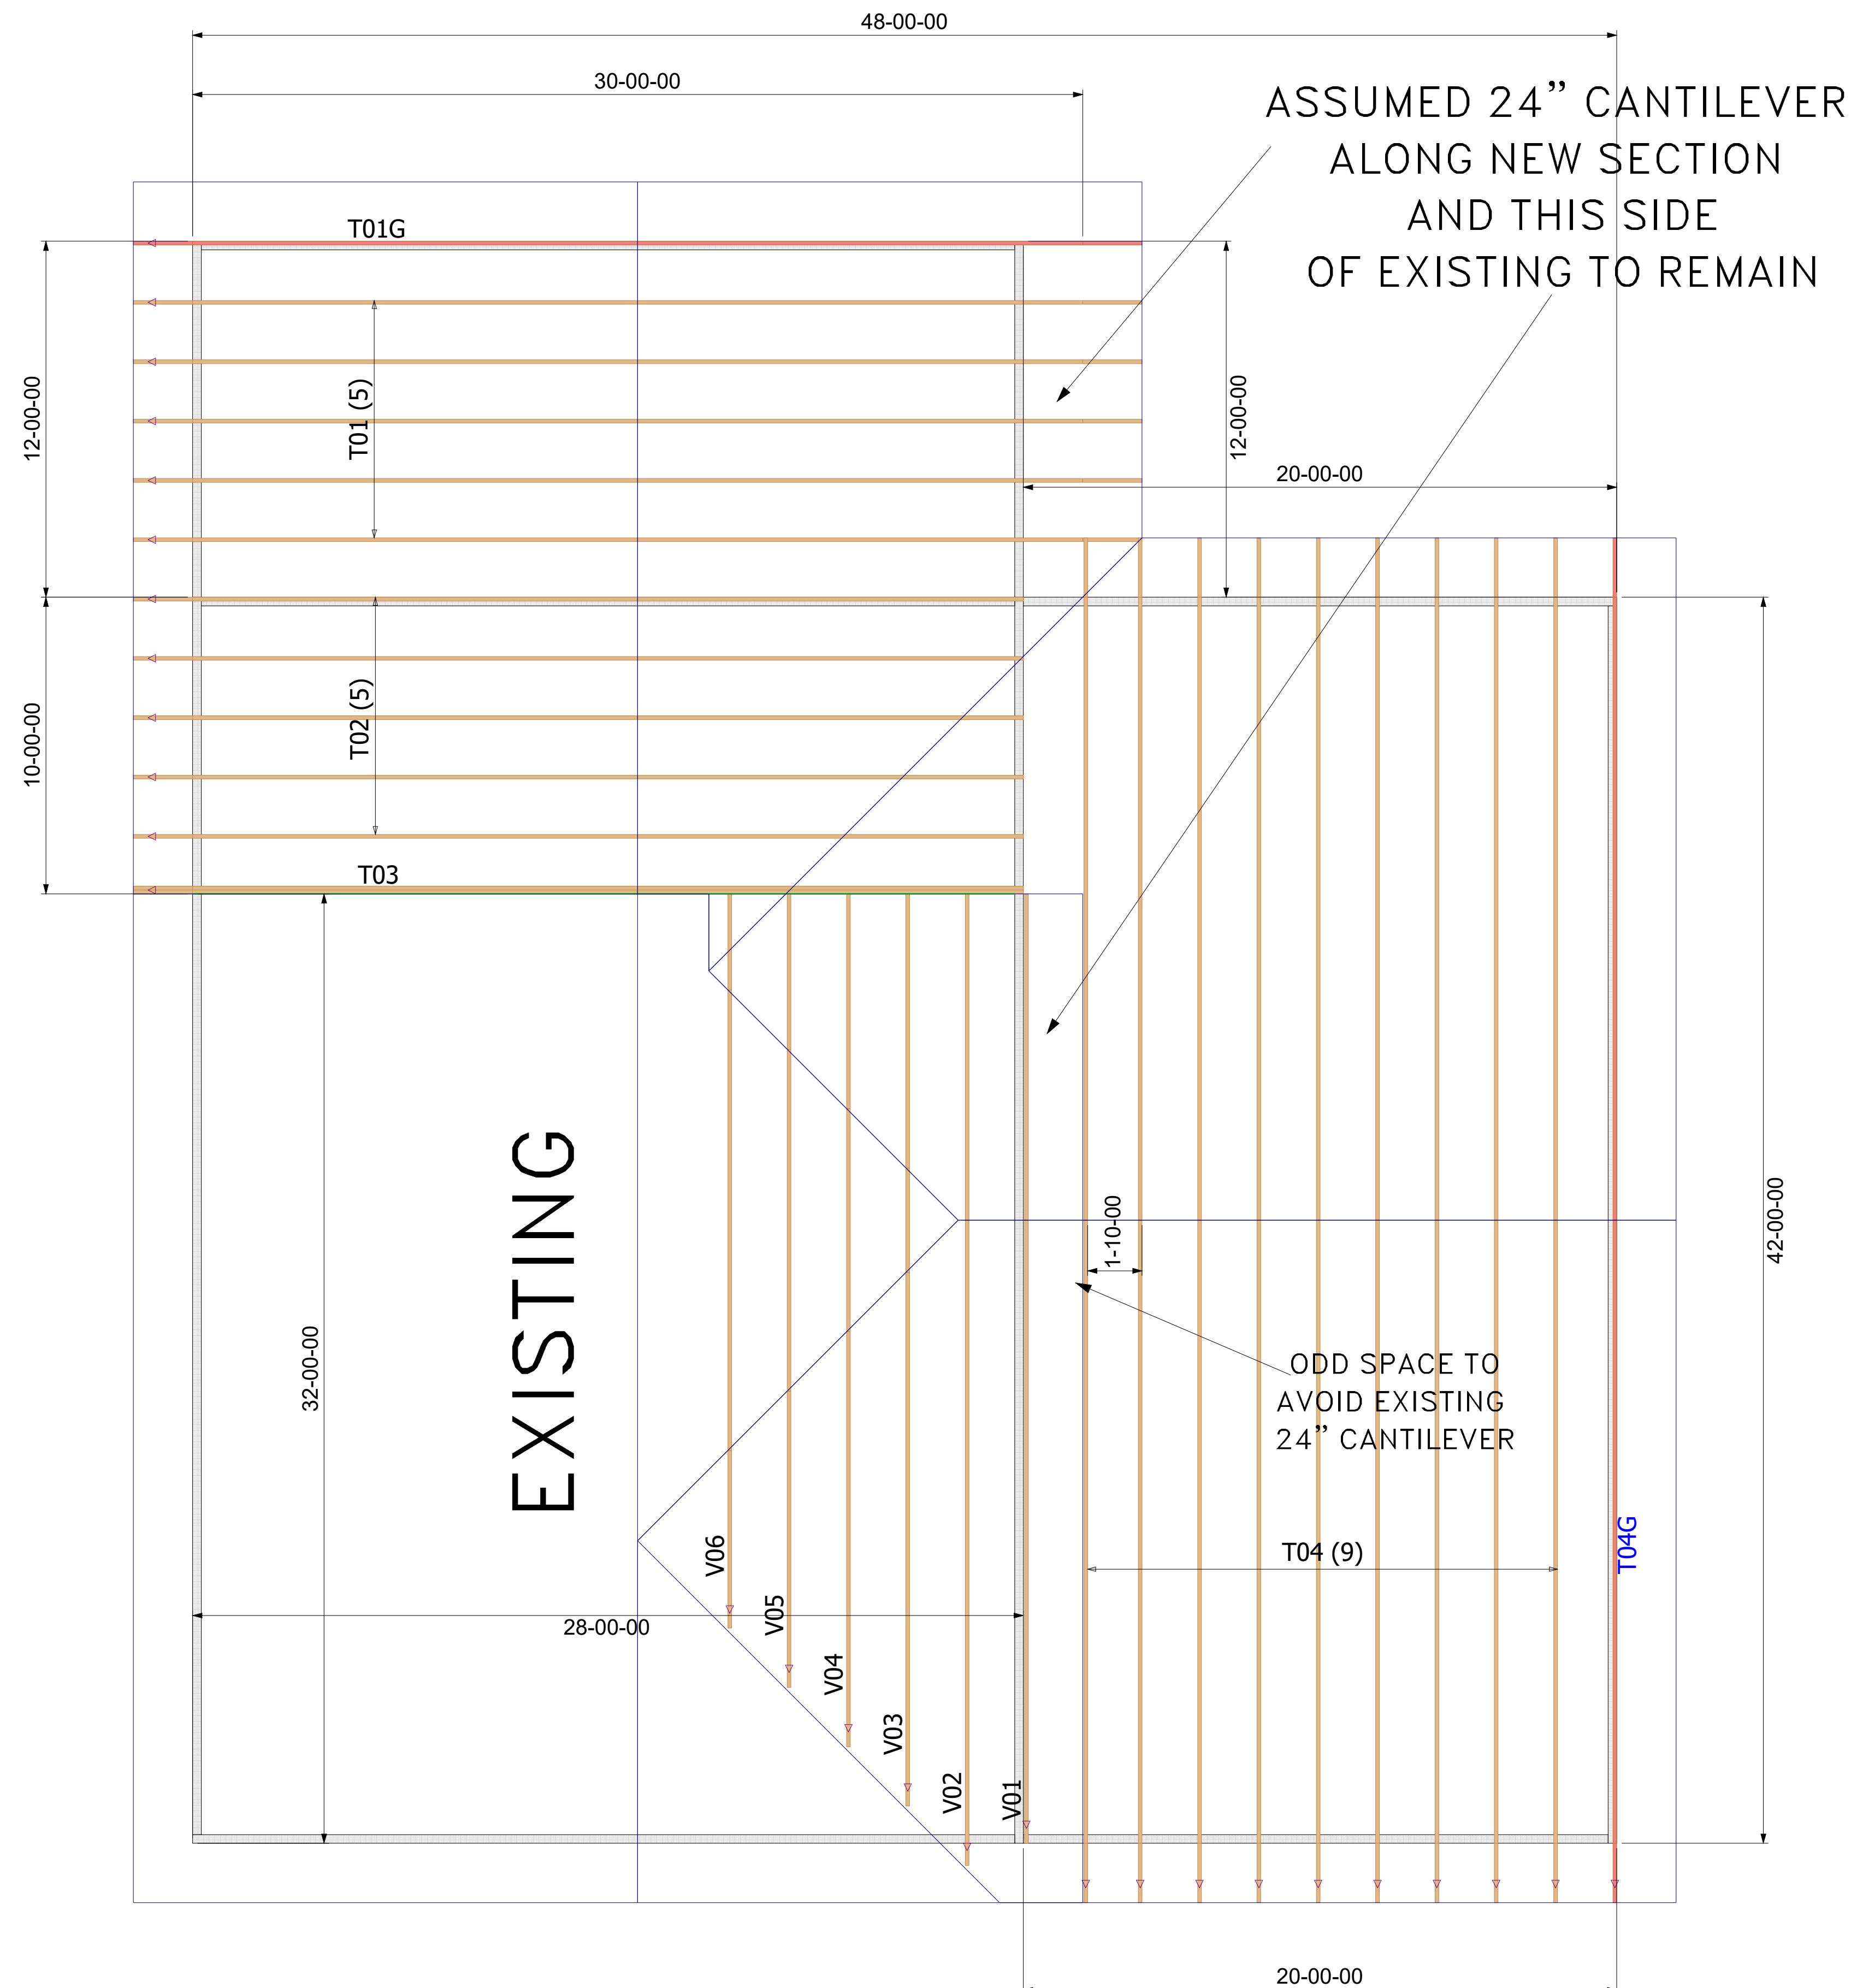
?? PITCH - 24" O/H

CONTRACTOR NEEDS TO VERIFY
PLATE HEIGHT
DIFFERENCE SHOWN IN PLANS
OR I CAN LEAVE VALLEY TO BE
CONV. FRAMED
